International Code Council

**ICC 500-2020 edition
Public Input Agenda with
Committee Votes and Public Comments
based on input received
on 2014 edition of the
ICC 500 Standard**

**For February, 2020
2nd Meeting – Teleconference**

FIGURE 804.9.5(4)
SECTIONAL DOOR ASSEMBLIES

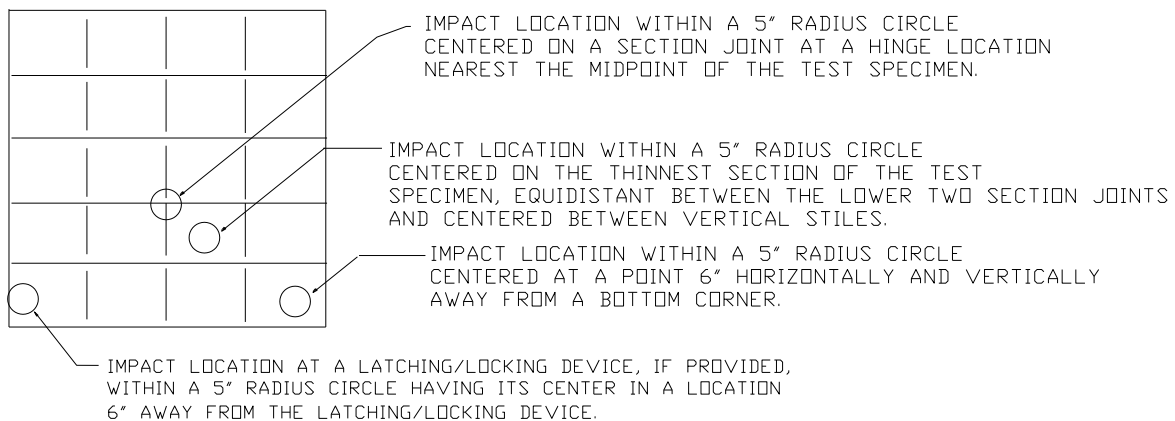
For sectional door assemblies, the door shall receive three impacts as shown in Figure 804.9.5(4) plus an additional impact on a latching/locking device if provided.

Reason: Clarify application of door impact provisions with respect to testing of rolling and sectional doors

FIGURE 804.9.5.2
ROLLING DOOR ASSEMBLIES

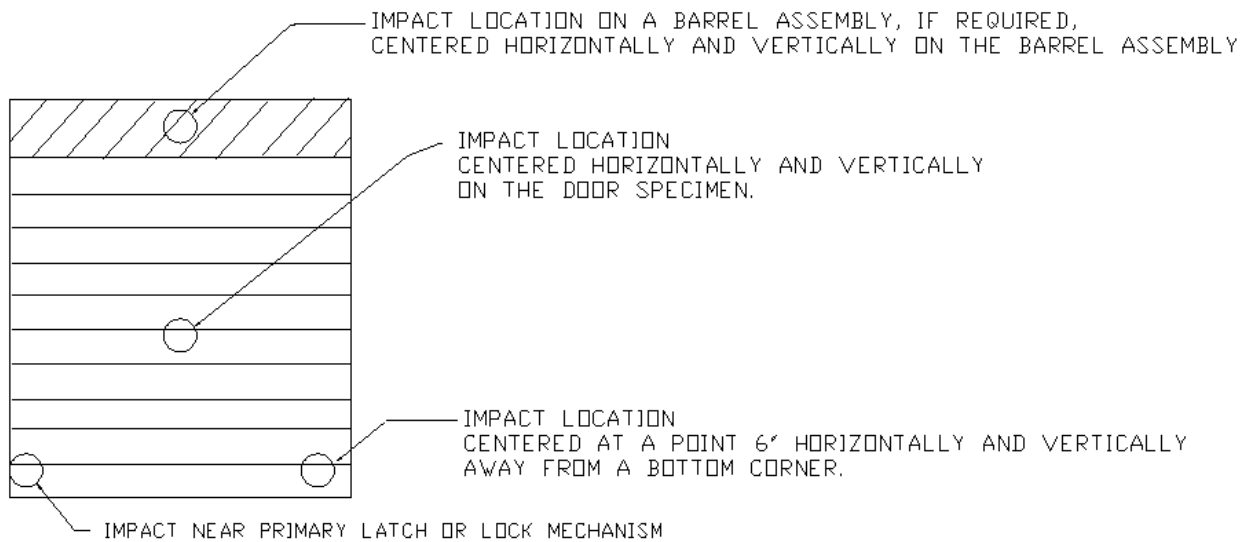
804.9.5.2 Rolling door assemblies. For rolling door assemblies, the door shall be impacted at the center of the door, at one bottom corner and within 6 inches (152.4 mm) of primary latches or operators, plus an additional impact centered on a barrel assembly as shown in Figure 804.9.5.2.

Exception: The barrel assembly is not subject to the additional impact where the entire barrel assembly is protected by the shelter envelope.

FIGURE 804.9.5.3
SECTIONAL DOOR ASSEMBLIES

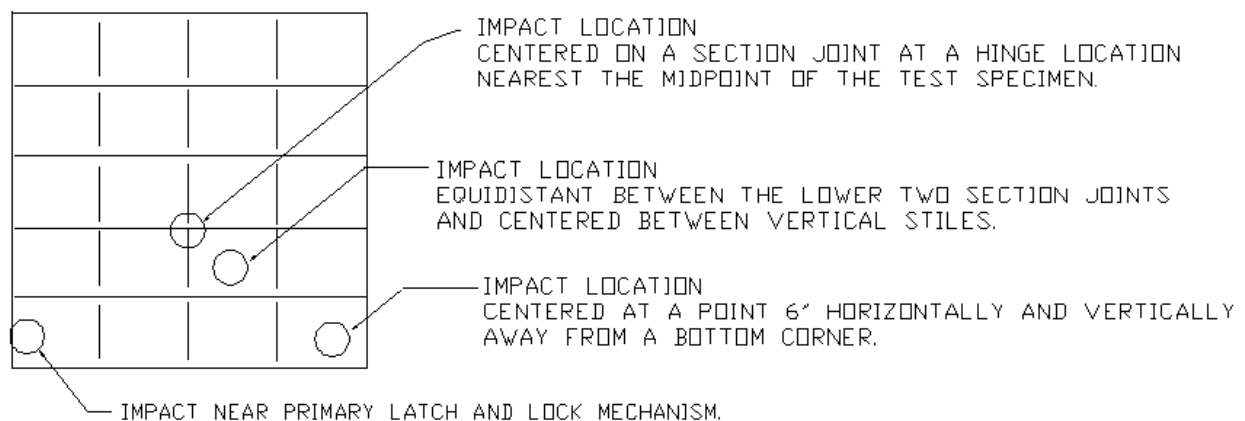
804.9.5.3 Sectional door assemblies. For sectional door assemblies, the door shall be impacted at a sectional joint nearing to the center of the door, within the lower two section joints and centered between two vertical stiles, at one bottom corner, and within 6 inches (152 mm) of the primary latches or operators as shown in Figure 804.9.5.3.

FIGURE 804.9.5(2)
DOORS AND OTHER ENTRY/EGRESS SYSTEMS

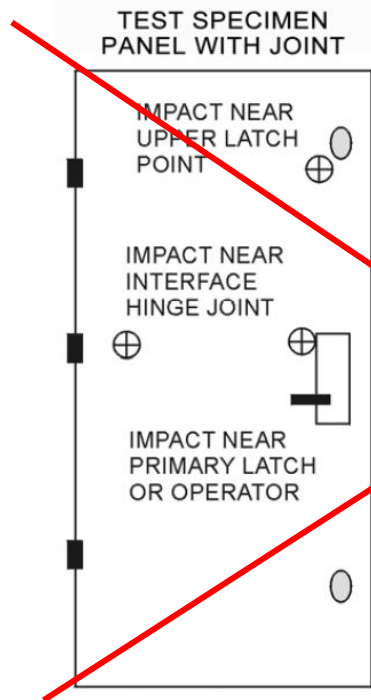
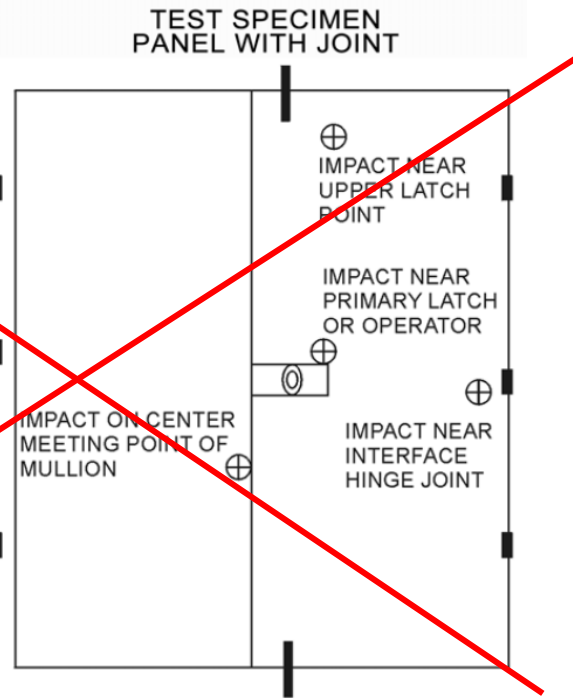
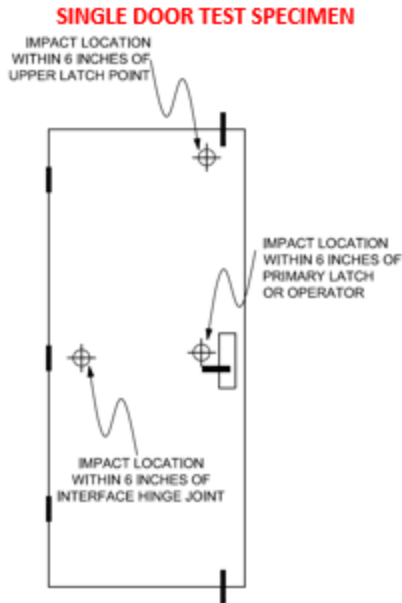
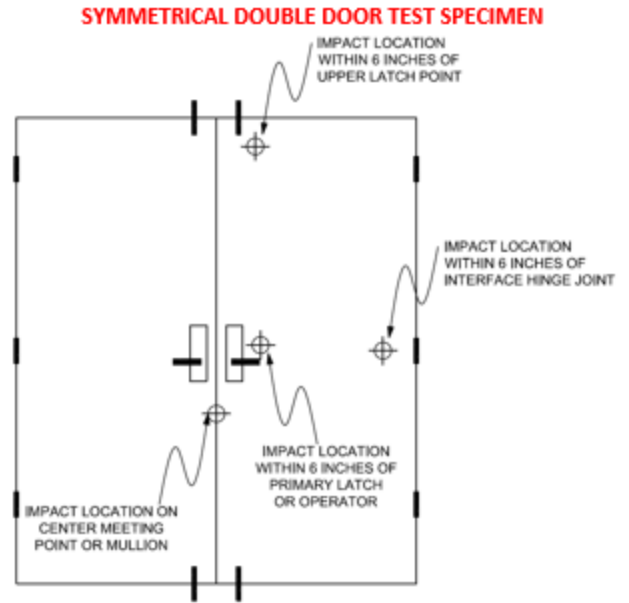
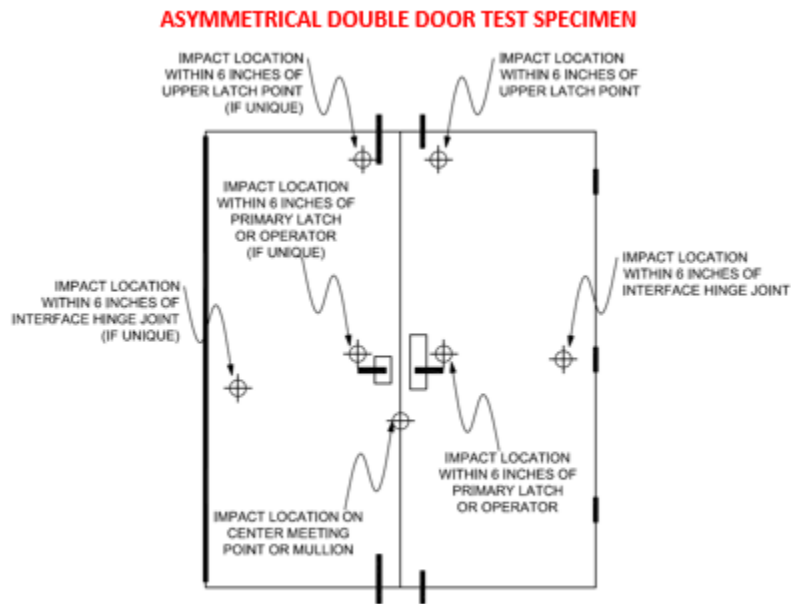
Reason: Figures 804.9.5(1) and 804.9.5(2) are the only impact location figures that use the term “near” in place of the actual locations required by the body text. The proposed figures clarify these locations.

Figure 804.9.5(2) requires an “impact on center meeting point *OF* mullion” whereas the text of Section 804.9.5 requires an “impact on a center meeting point *OR* mullion”. The proposed Figure 804.9.5(2) aligns the figure text with the text of Section 804.9.5.

Figure 804.9.5(2) contains some misaligned elements (left hinges, center impact). The proposed Figure 804.9.5(2) corrects these misalignments.

FIGURE 804.9.5(1) – SINGLE DOOR TEST SPECIMEN

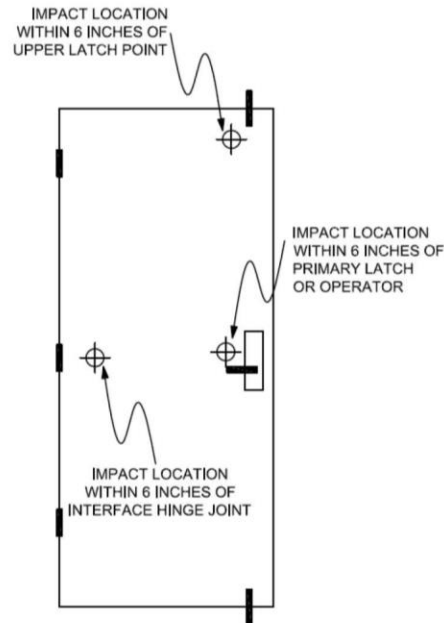
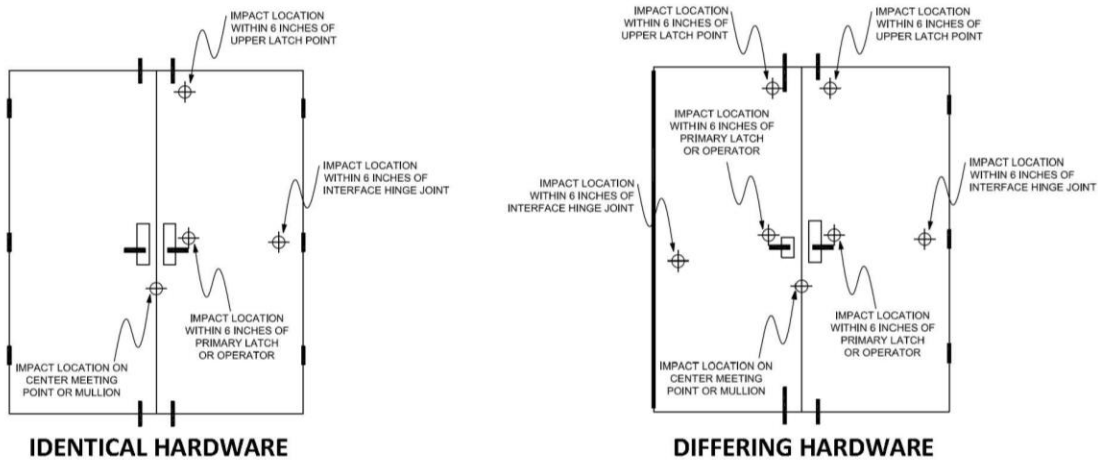
804.9.5 Doors ~~or other entry/egress systems~~. All door assemblies ~~and other entry/egress systems~~ shall be impacted within 6 inches (152.4 mm) of an interface hinge joint, within 6 inches (152.4 mm) of an upper latch point and within 6 inches (152.4 mm) of center primary latches or operators as shown in Figure 804.9.5(1).

Exception: More than four impacts shall be permitted to be made on a single specimen with mutual consent of the test sponsor and test laboratory.

FIGURE 804.9.7.2
DOORS SUBJECT TO REBOUND IMPACT

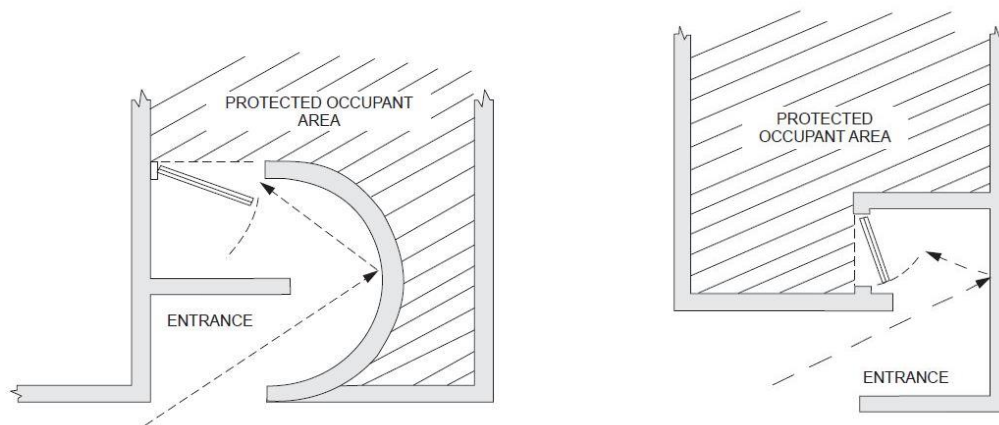
804.9.7.2 Door subject to rebound impact. Where the alcove or baffled entry system prevents a first impact of the design missile on the door but the door is subject to a rebounded impact of the design missile after it has impacted one surface meeting the requirements of Section 306.2 possible (~~see [as detailed in](#) Figure 804.9.7.2~~), then a door assembly shall meet the wind load requirements of Section 304 and the debris impact requirements of Section 305 except that the missile shall be, at a minimum, a 9-pound sawn lumber 2 by 4 traveling at 50 feet per second (15.2 m/s). Entry systems having doors that are protected from the initial and first rebounded impacts of debris shall comply with the requirements of Section 804.9.7.1.

Reason: The way figures are referenced is not consistent and does not make the figure part of the requirement. Using “as detailed in” or “as shown in” would be consistent with the figure references of impact location in 804.9. In Items 1, 2 and 3 of Section 804.9.7, “Examples of this type of system are shown in Figure...” is not needed. As written it is editorials information, not a requirement; and the figures are referenced in each of the referenced sections.

FIGURE 804.9.7.3
DOORS SUBJECT TO FIRST IMPACT

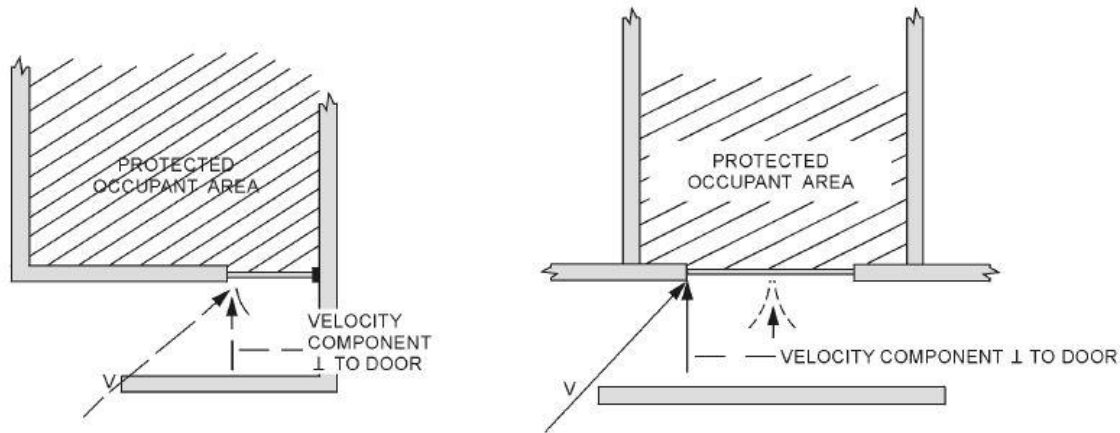
804.9.7.3 Door subject to first impact. If a first-strike angle missile impact on the door is possible (~~see as detailed in~~ [Figure 804.9.7.3](#)), then the door is deemed suitable if the door assembly meets the wind load requirements of Section 304 and the door assembly meets one of the following debris impact criteria:
